Pawla Knitwear Ltd

Isdair, Fatullah, Narayangong
(23.633828,90.492207)
19th April 2014

Executive Summary (continued)

Column Stresses

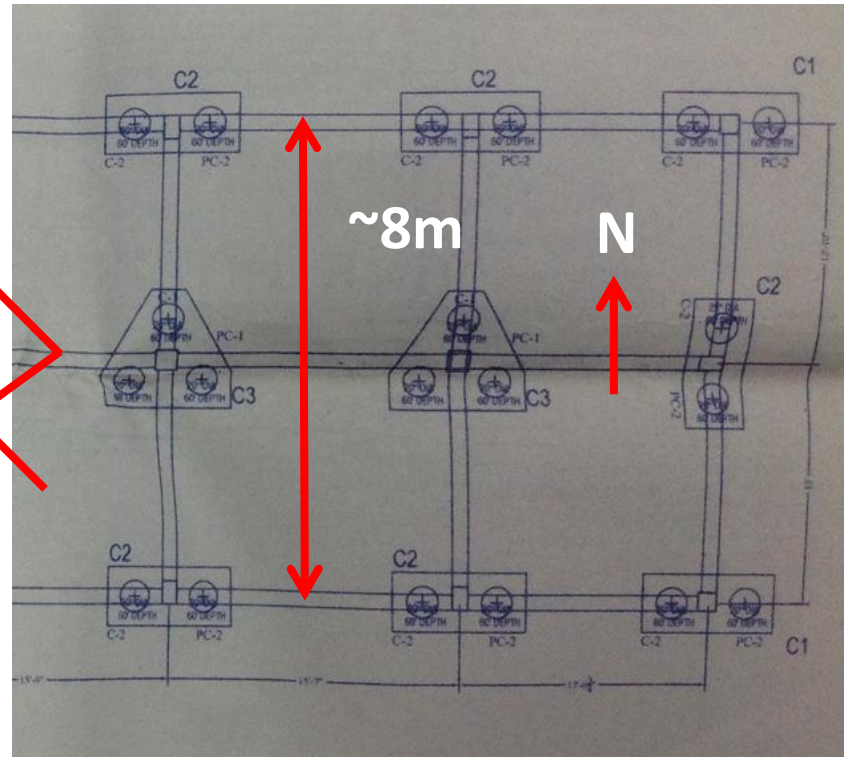
Preliminary calculations indicate that column working stress is at a high level in all parts of the buildings.

Phase III: Tested Ground Floor Column – Stone Aggregate

Phases I & II: Tested Ground Floor Column – Brick Chip Aggregate

- The area highlighted above is to be vacated of all storage and personnel at Levels 1 to 7. Personnel access to the toilets is permitted.
- Ensure the live load in all other areas at Levels 1 to 7 is limited to **1.5kPa**.
- Verify insitu concrete stresses by min. 4 no. 100mm dia. cores
- A **Detail Engineering Assessment** of the building to be commenced, see attached Scope

Building lateral stability

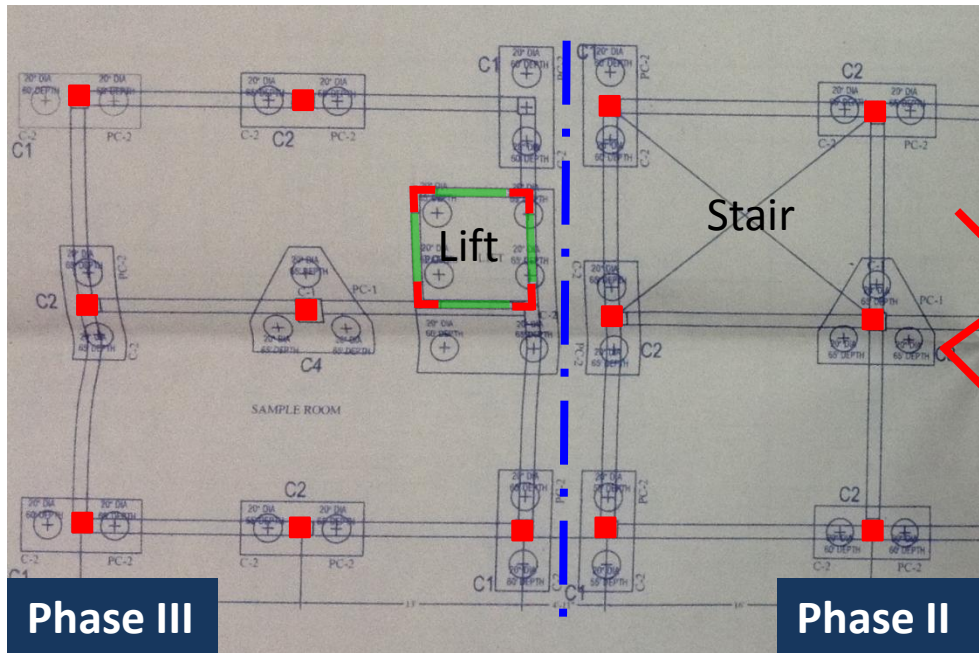
Height to north-south plan width ratio > 3 . Additional vertical load expected in existing highly-stressed columns during an extreme hazard event.

- A **Detail Engineering Assessment** of the building is to be commenced, as Item 1. Ensure that lateral stability forms part of the assessment.

Lateral stability of structure

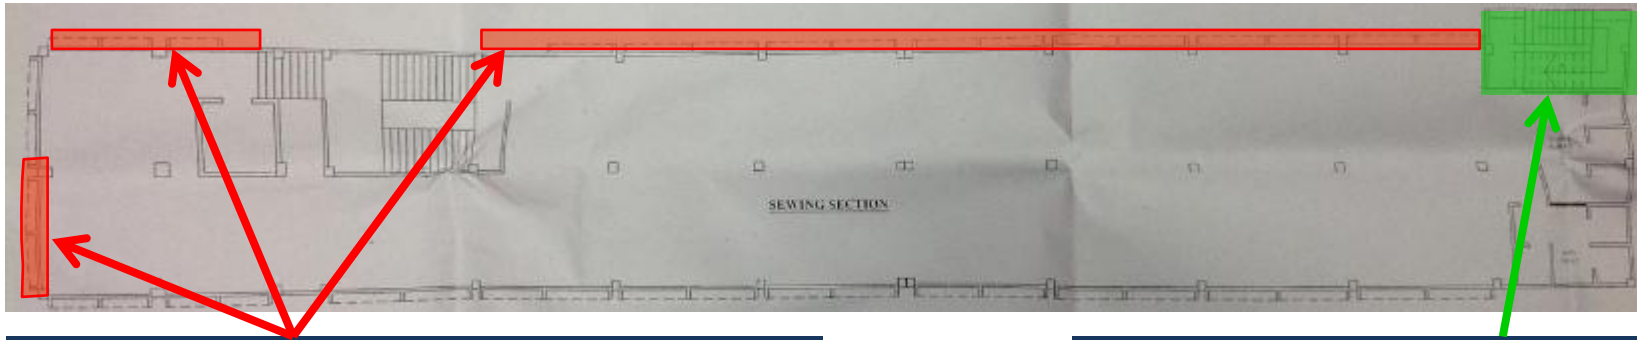
Phases I, II and III are separated by movement joints. It should be noted that:

- Movement joints have been filled with non-structural material.
- Pounding may occur where joints have been filled.
- Movement joints reduce redundancy of complete building structure.

No reinforced concrete shear walls. Limited vertically continuous non-structural masonry infill walls. Primary lateral load path relies on floor column moment frame action.

Discrepancies between design and construction

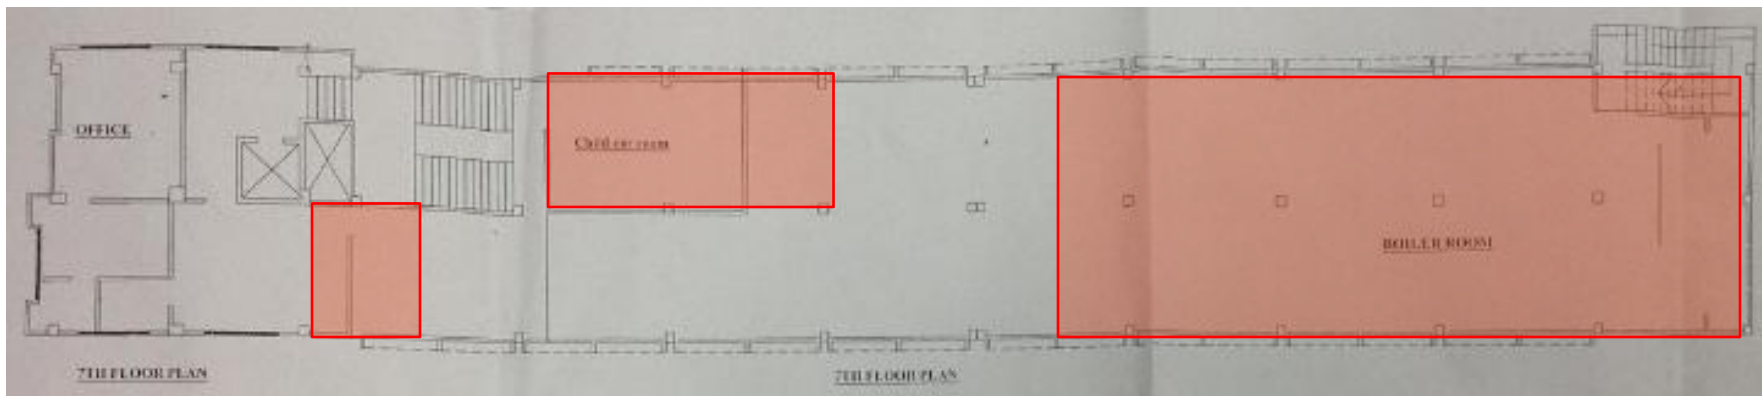
Typical plan showing areas where cantilevers do not appear on the permit / structural drawings on some levels.

Steel stair not documented on structural drawings.

Adequate documentation does not exist for any structure above Level 7.

Mezzanine floor does not appear on the structural drawings.

Incomplete structural drawings do not reflect the constructed building.

- As part of Detail Engineering Assessment (see Item 1), ensure that accurate as-built documentation and drawings are produced.

- Detail Engineering Assessment to be completed, as Item 1.
- Issue accurate as-built documentation and drawings.

Façade stability

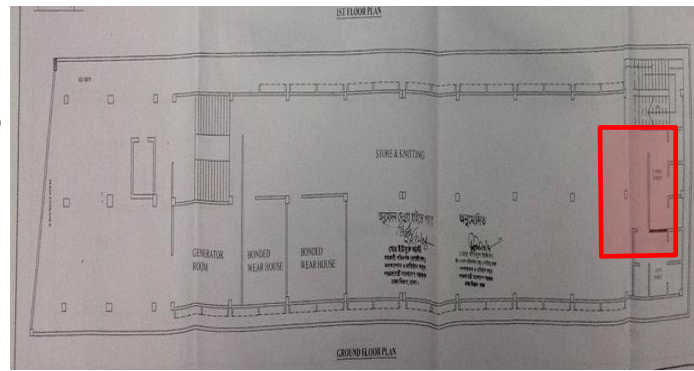
Cracking was evident at a number of positions around the façade particularly near openings for windows.

Severe corrosion and concrete spalling was evident with rebar exposed at some locations.

- Building engineer to review façade and advise if any remediation is necessary to ensure structural sufficiency for the full design life.
- As a minimum, exposed rebar should be protected against further corrosion and area of damaged concrete should be repaired.
